ORIGINATION FORM

Proposed Revisions to a Standard Plans Index

Index Number: 102-200

Index Title: TEMPORARY ACROW 300 SERIES DETOUR
BRIDGE GENERAL NOTES AND DETAILS

LAST REVISION		DESCRIPTION:	FY 2022-23 STANDARD PLANS		TEMPORARY ACROW 300 SERIES DETOUR BRIDGE GENERAL NOTES AND DETAILS	INDEX 102-200	SHEET 2 of 7
11/01/20	1		FDOT

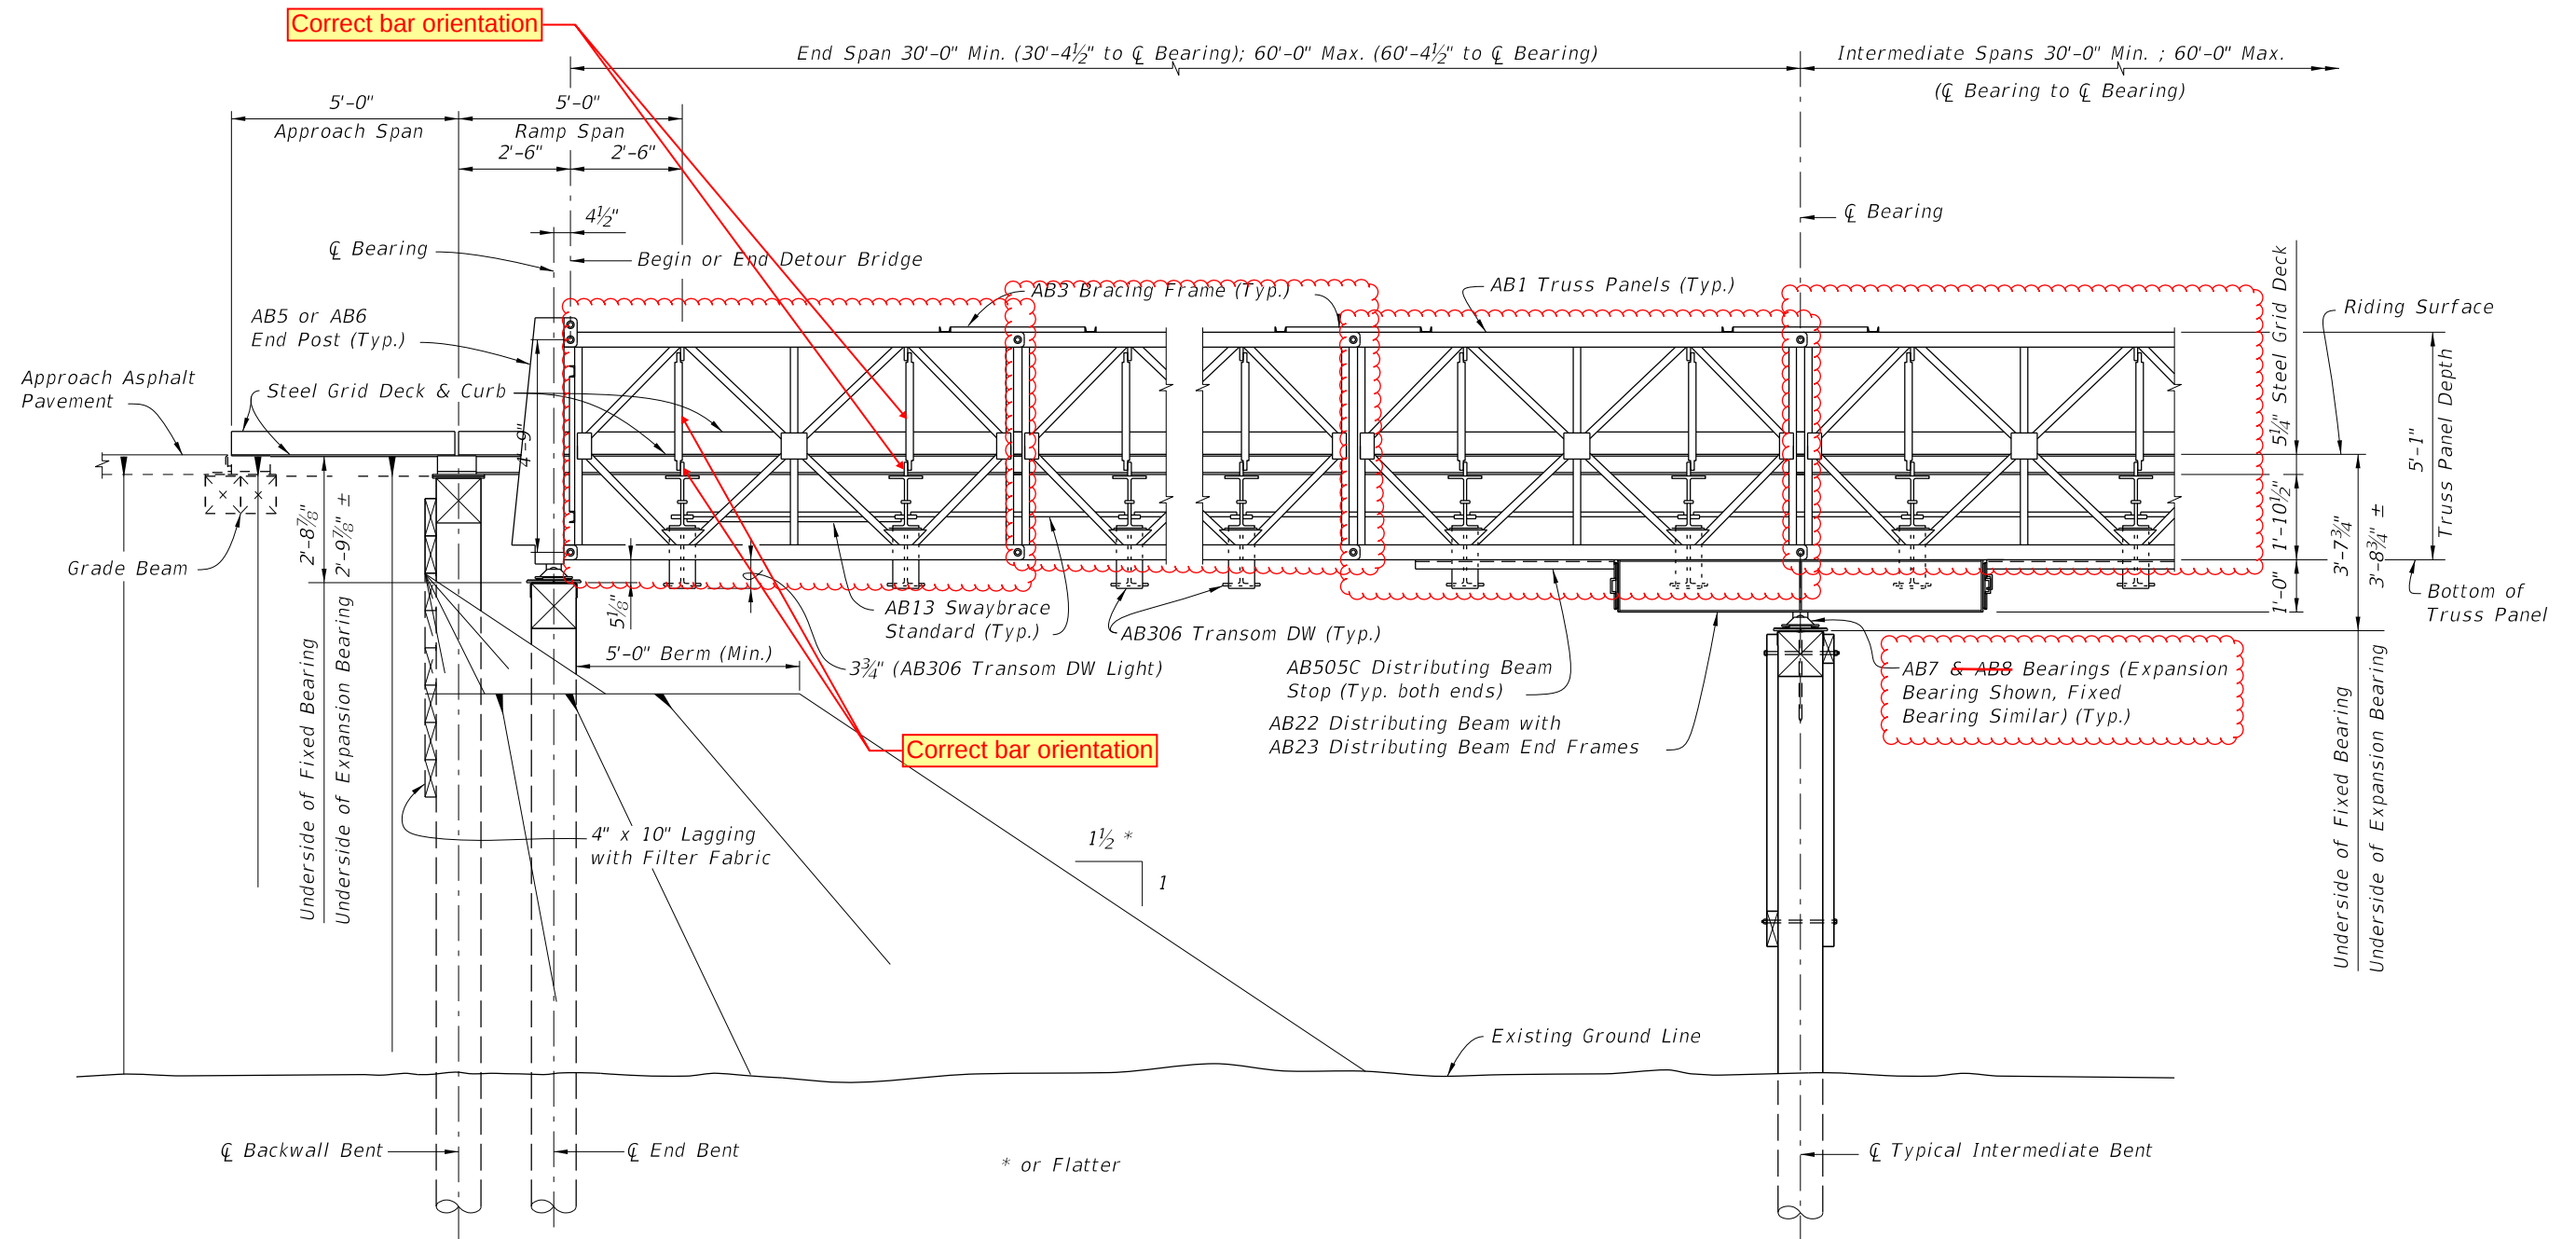
Sheet 2: Removed double bearing note

Sheet2-6: Currently FDOT only has single bearings in inventory.

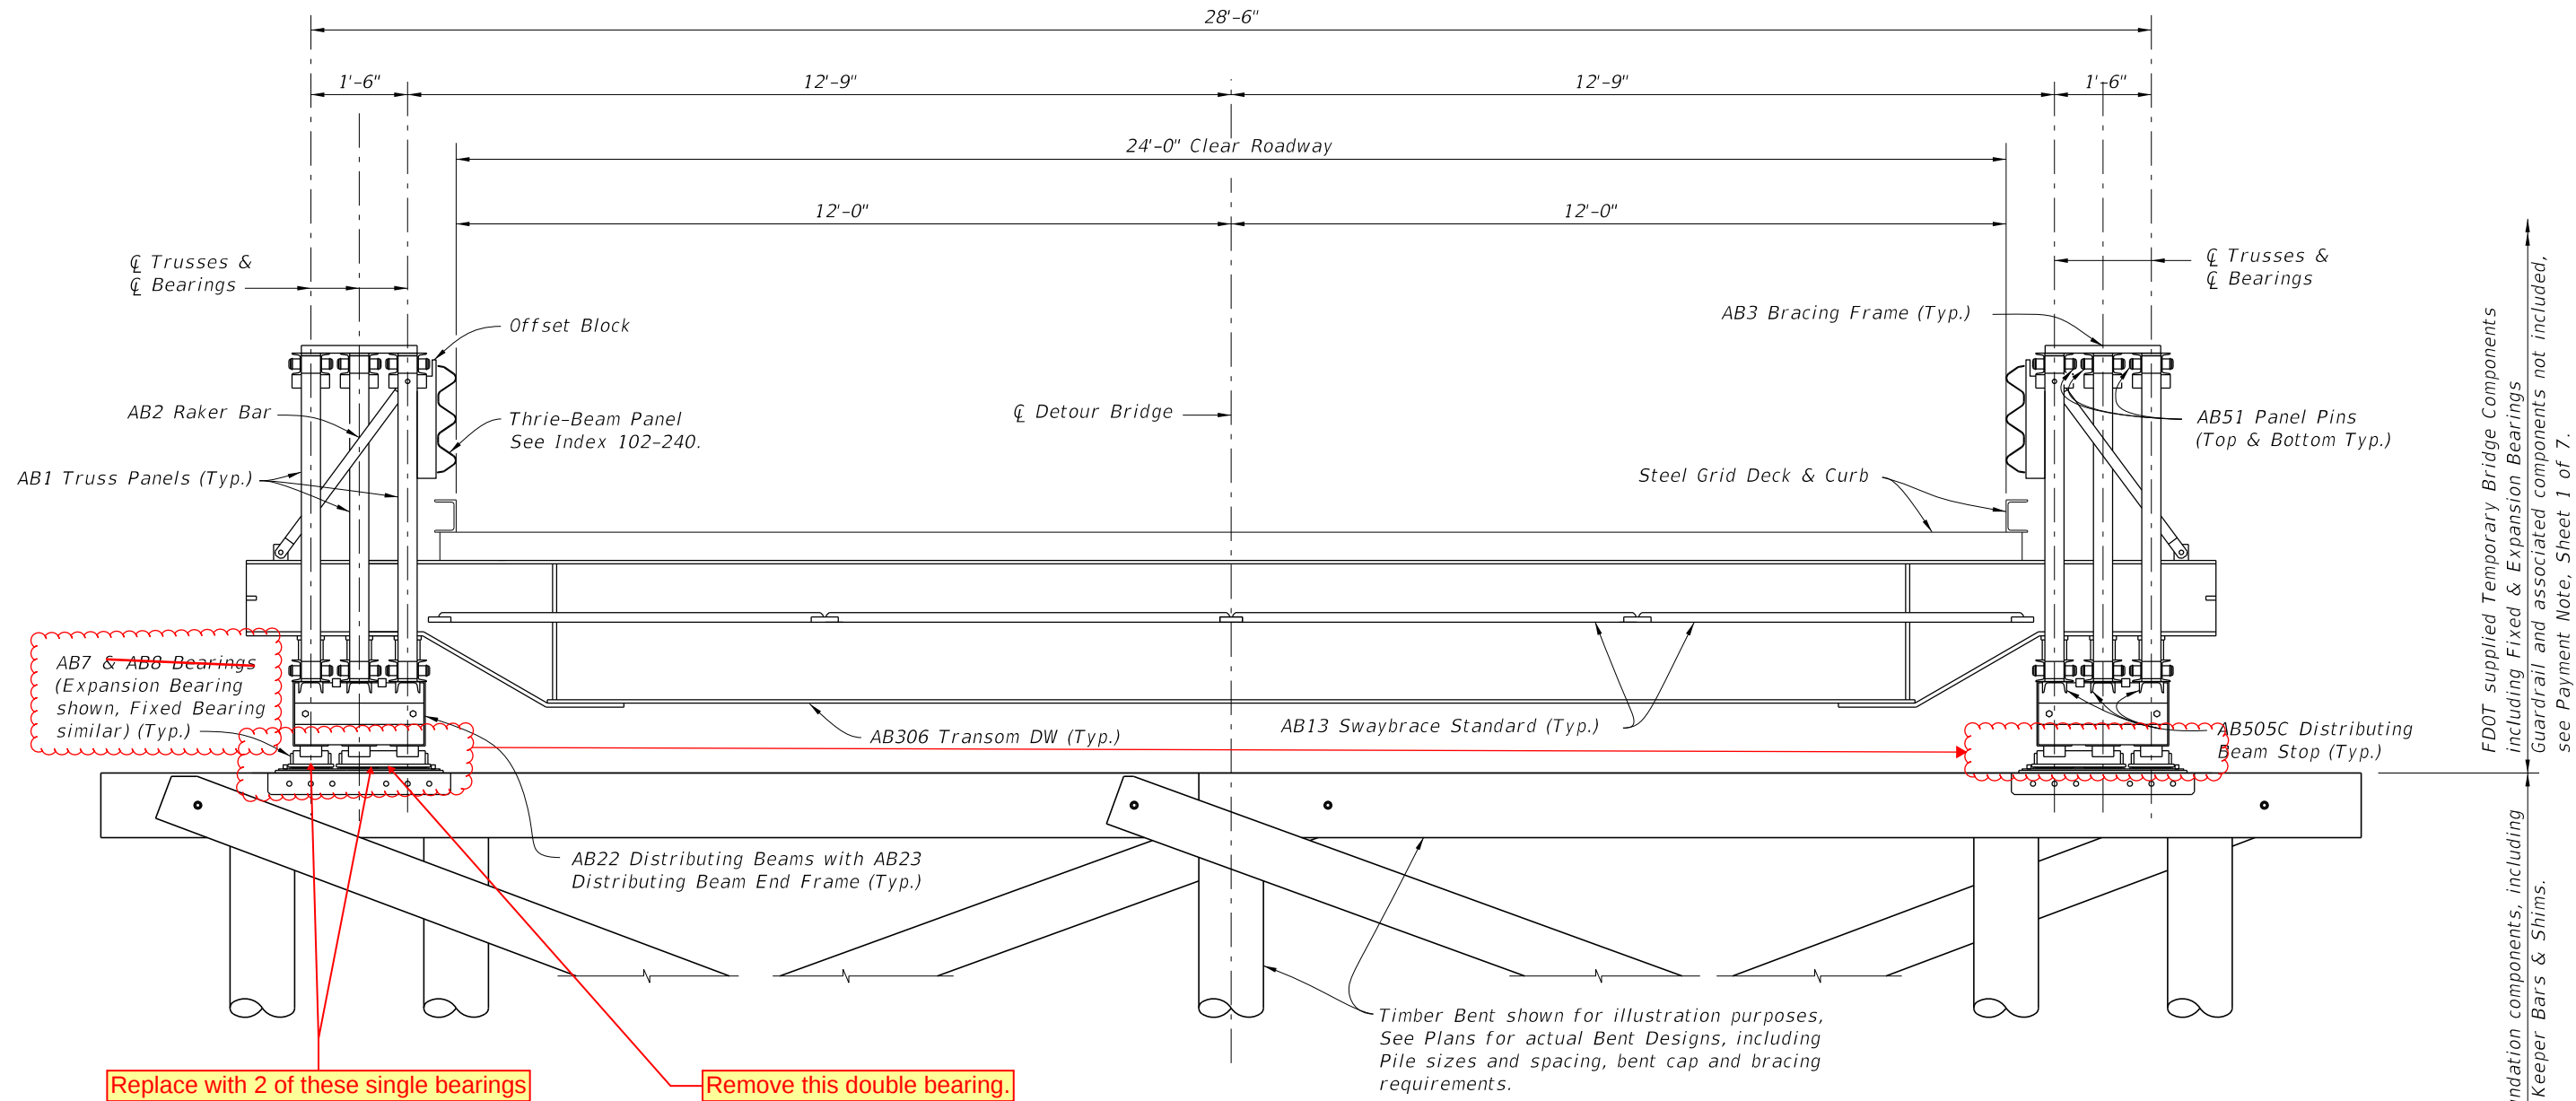
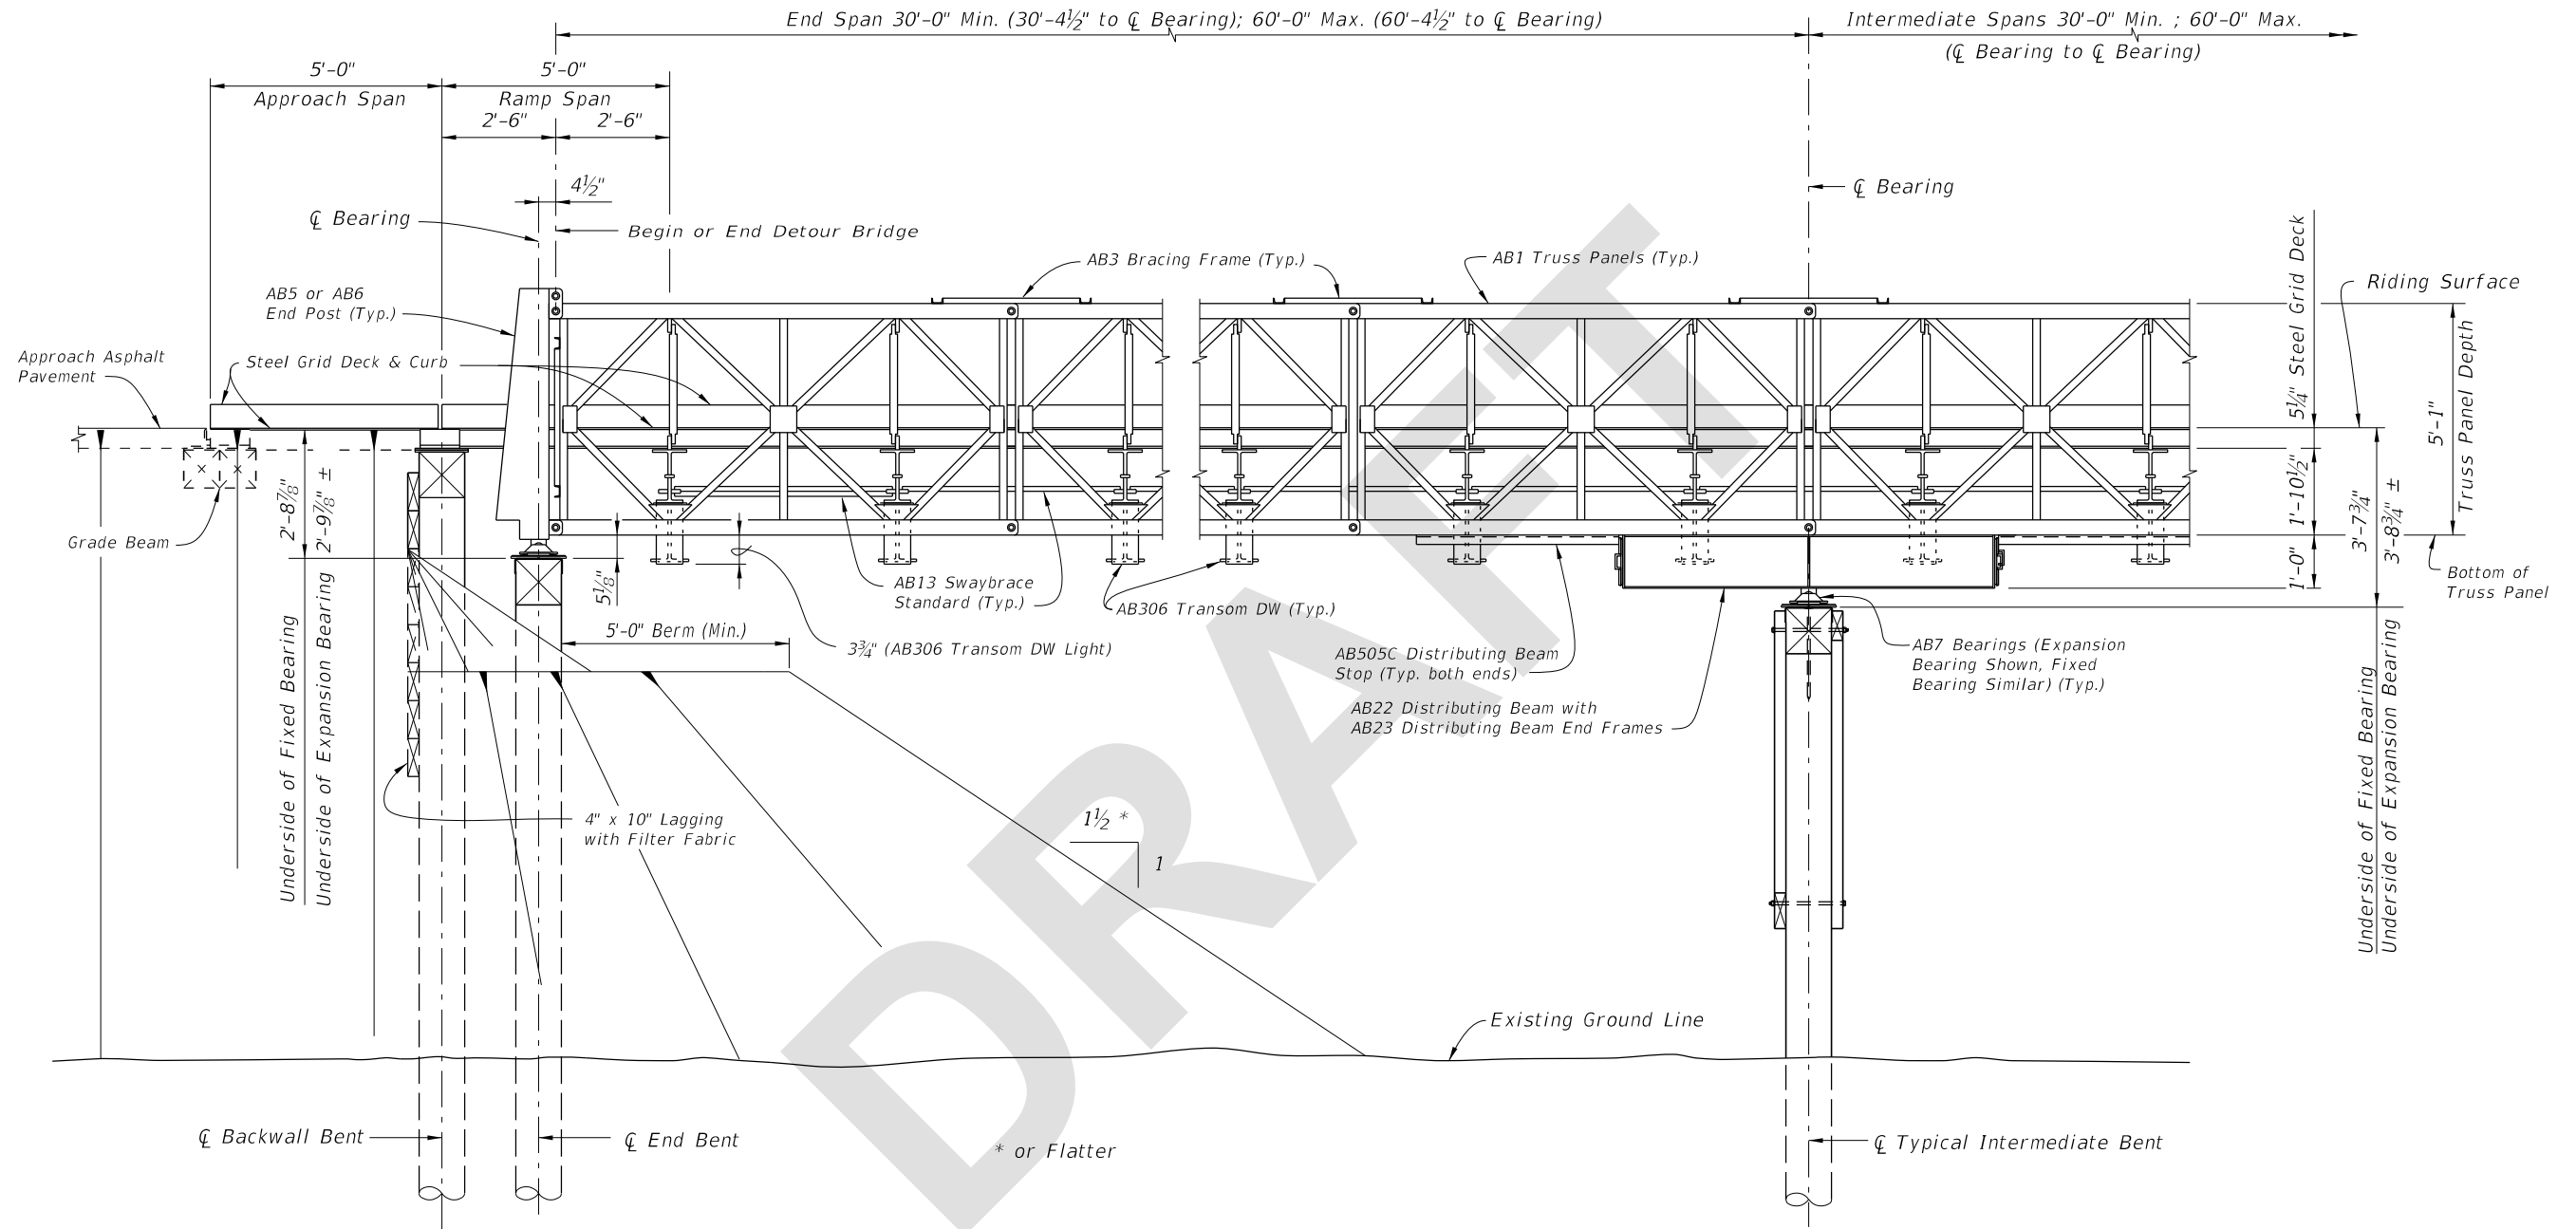
Sheet 3: Corrected the raker beam connection; Removed double bearing notes.
